Haddam Neck Plant

Proposed Revision to Technical Specifications

Administrative Changes - Spent Fuel Pool and New Fuel
Storage Racks - Marked up pages of Technical Specifications

January 1994

FIGURE 3.9-1 SPENT FUEL POOL RACK MINIMUM BURNUP REQUIREMENTS FOR ALTERNATING ROWS STORAGE CONFIGURATION

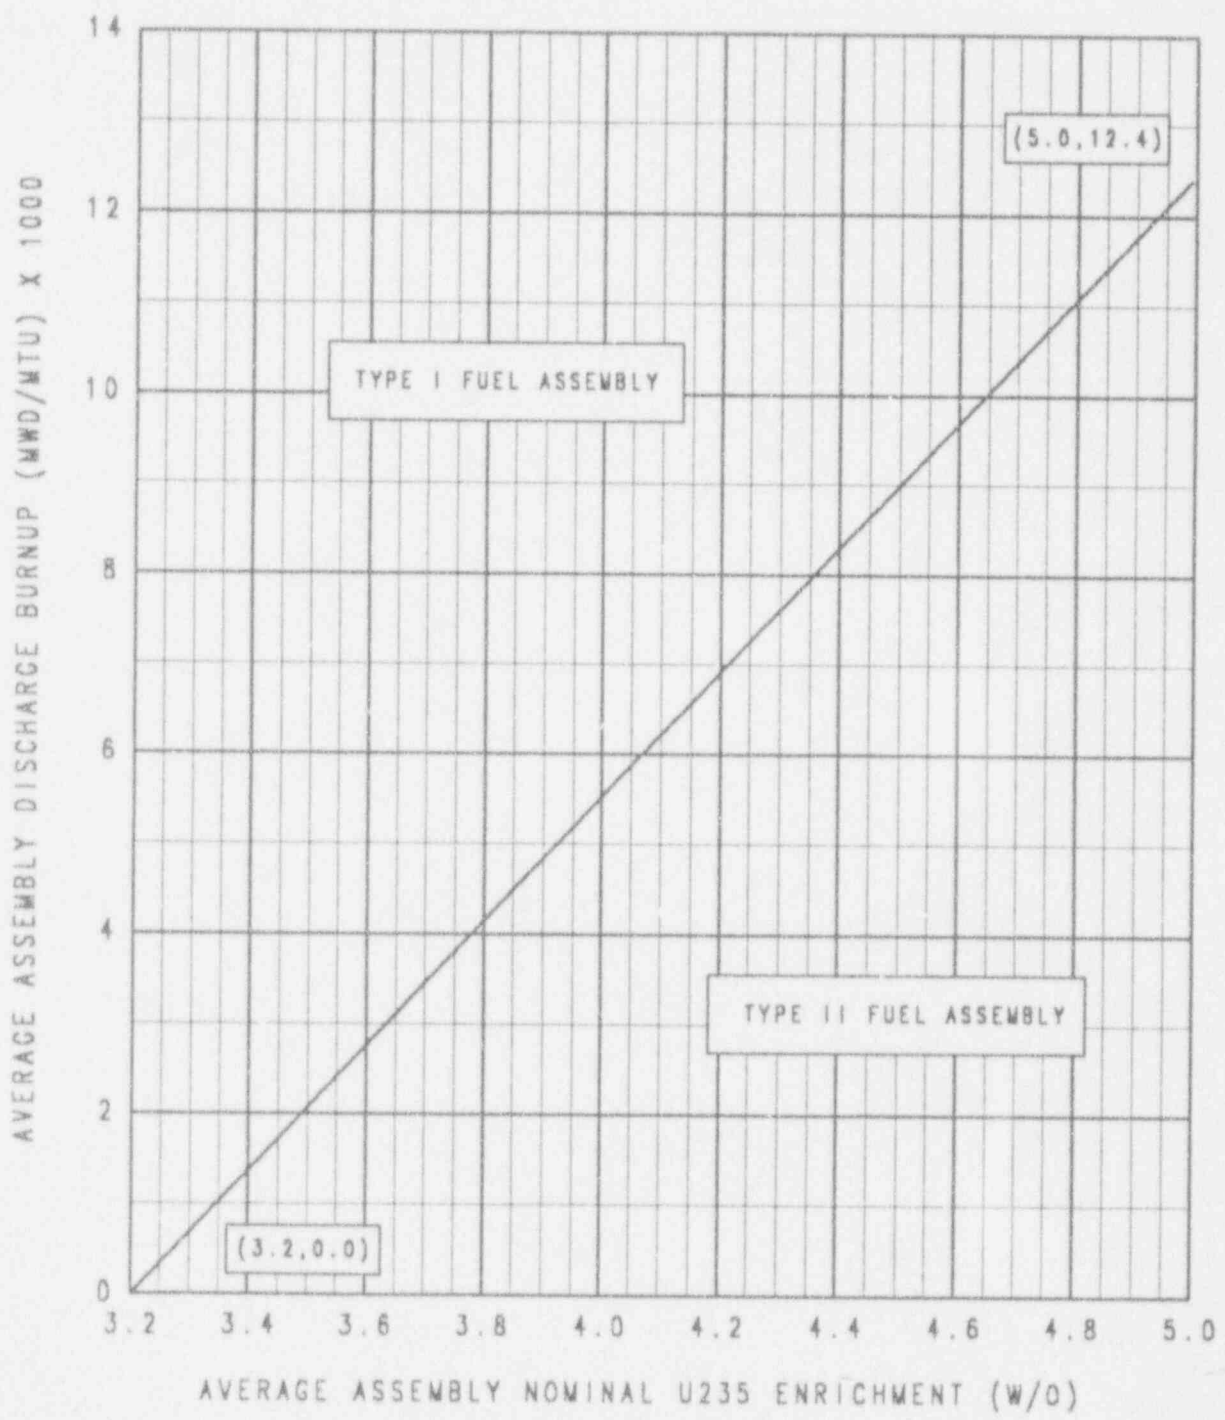
4.9.14 Ensure that all fuel assemblies to be placed in the spent fuel pool are within the enrichment and burn-up limits of Figure 3.9-1 by checking the assembly's design and burn-up documentation. TYPE I FUEL ASSEMBLIES and TYPE II FUEL ASSEMBLIES will be stored as shown in Figure 3.9-2

FIGURE 3.9-2 SPENT FUEL POOL RACK ALTERNATING ROW STORAGE CONFIGURATION

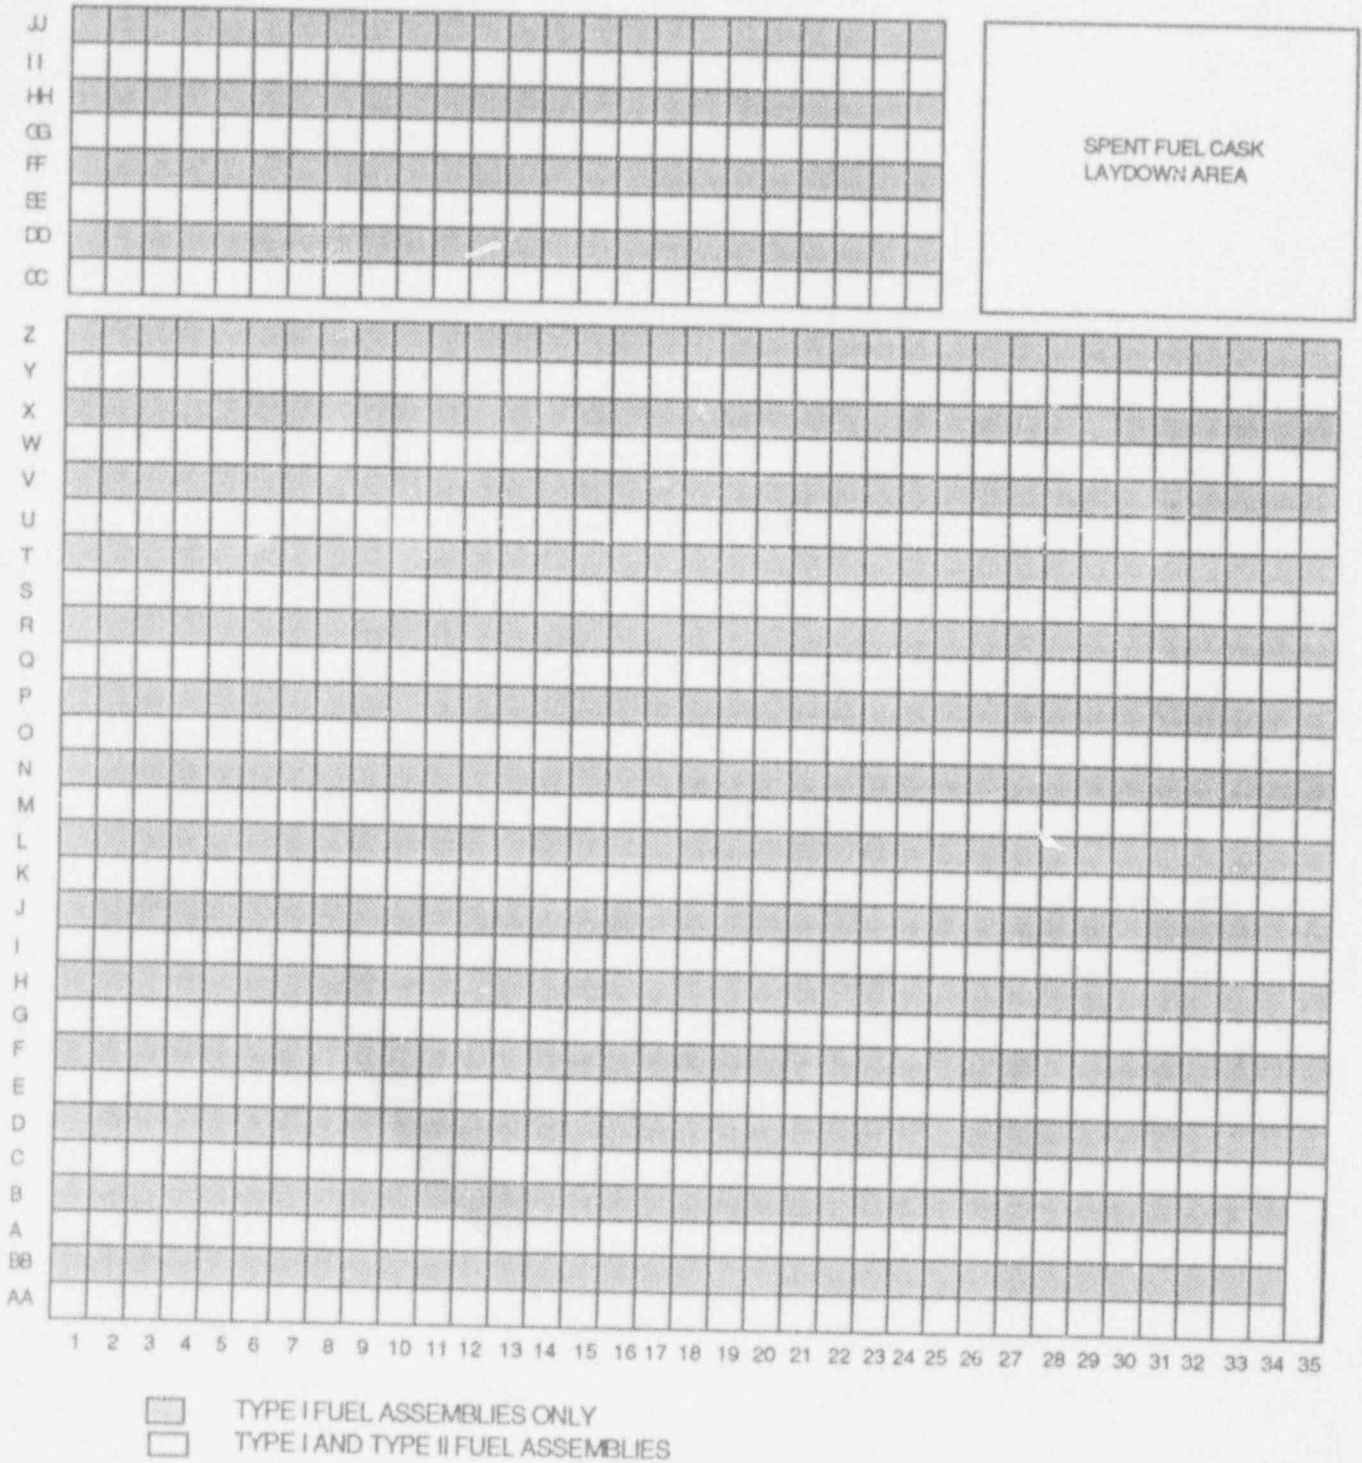
b. ~~A maximum fuel enrichment to be stored in the fuel pool will be a nominal 4.00 weight percent U-235 for stainless steel clad fuel assemblies and a nominal 3.90 weight percent for Zircaloy-4 clad fuel assemblies.~~ FUEL ASSEMBLIES WILL BE STORED IN AN ALTERNATING ROW CONFIGURATION. TYPE I AND TYPE II FUEL ASSEMBLIES WILL BE STORED IN ACCORDANCE WITH THE REQUIREMENTS OF SPECIFICATION 3.9.14.

FIGURE 5.6-1 NEW FUEL STORAGE RACK MINIMUM IFBA REQUIREMENTS

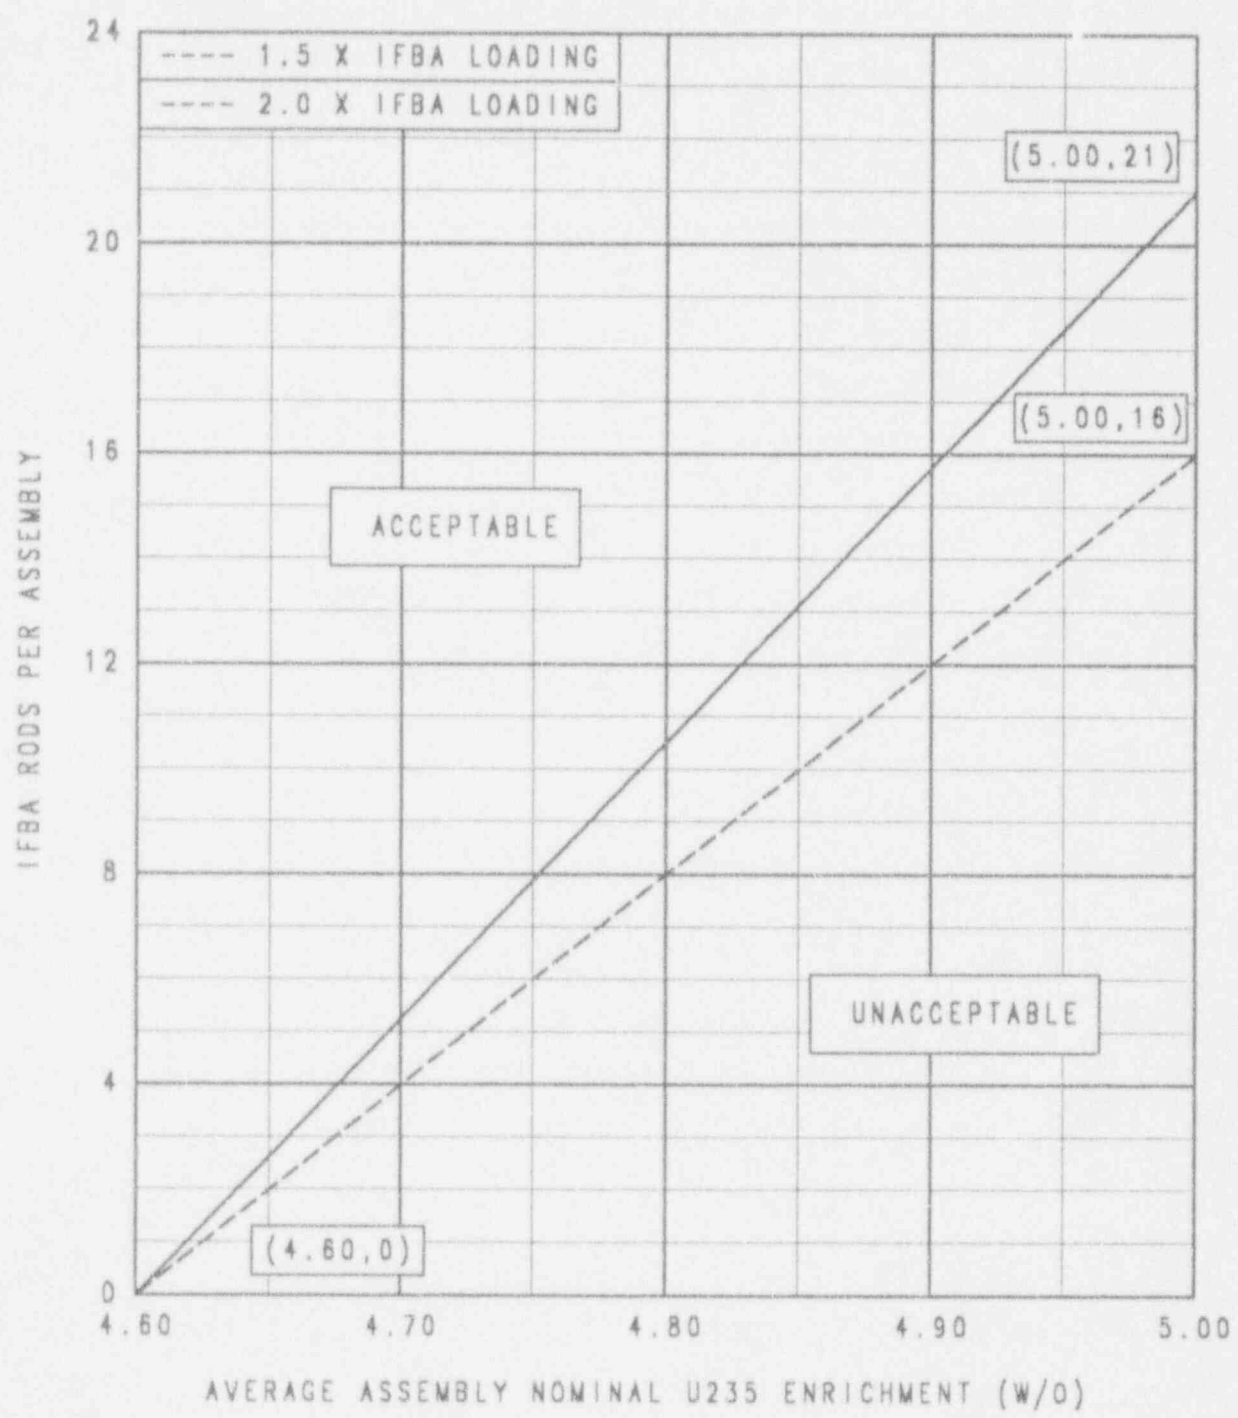
THE MAXIMUM FUEL ASSEMBLY ENRICHMENT IN THE NEW FUEL STORAGE RACKS WILL BE 5.0 WEIGHT PERCENT U-235 (NOMINAL). NEW FUEL ASSEMBLIES WITH AN AVERAGE ENRICHMENT GREATER THAN 4.60 WEIGHT PERCENT U-235 (NOMINAL) MUST CONTAIN

5.6.2 The spent fuel storage pool is designed and shall be maintained to prevent inadvertent draining of the pool below elevation 27.0 feet MSL. INTEGRAL FUEL BURNABLE ABSORBERS (IFBA) RODS IN ACCORDANCE WITH THE REQUIREMENTS OF FIGURE 5.6-1. NEW FUEL ASSEMBLIES WILL BE STORED IN ACCORDANCE WITH THE REQUIREMENTS OF FIGURE 5.6-2.
